# UNITED STATES PATENT AND TRADEMARK OFFICE

### Office Action Summary

10/583,974

### DETAILED ACTION

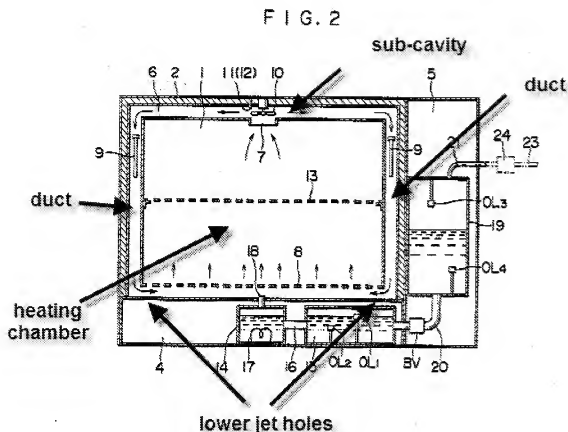
Ohata discloses a lower jet hole on each side wall of the heating chamber (see annotated Fig. 2 of Ohata below.

Ohata teaches a duct connecting between a sub-cavity and a side jet hole (see annotated Fig. 2 below).

Ohata teaches steam guided from a sub-cavity located in the ceiling of a heating chamber in which the steam is directed to a side jet hole on each side of the heating chamber so that the steam can impinge upon the food product from below (see annotated Fig. 2 below).

Ohata teaches a fan (7) that moves steam from the cooking chamber to be recirculated to apertures positioned on the lower part of each side wall of the heating chamber (see Fig. 2).

Ohata teaches a support rack at 13 where the food product is positioned in a state "floating" above the floor of the heating chamber (8) and where a side jet hole is located below the support so that steam enters the chamber and cooks the food product from below (see Fig. 2 where the heating chamber has two oppositely opposing side ducts that have openings at the bottom of the heating chamber where the steam enters through apertures at 8).

In regards to claim 3, Hara in view of Ohata discloses the steam cooking apparatus of claim 1, wherein the side jet hole (lower jet holes, see annotated Fig. 2, Ohata) is so positioned and/or directed that, when the food is supported in a state floating above the floor surface (food product is placed on 13) of the heating chamber by the supporting means (13), the steam jetted out from each side meets under the food (steam is directed from the sub-cavity through side ducts and enters through the lower jet holes meeting below and impinging on the food product from below).
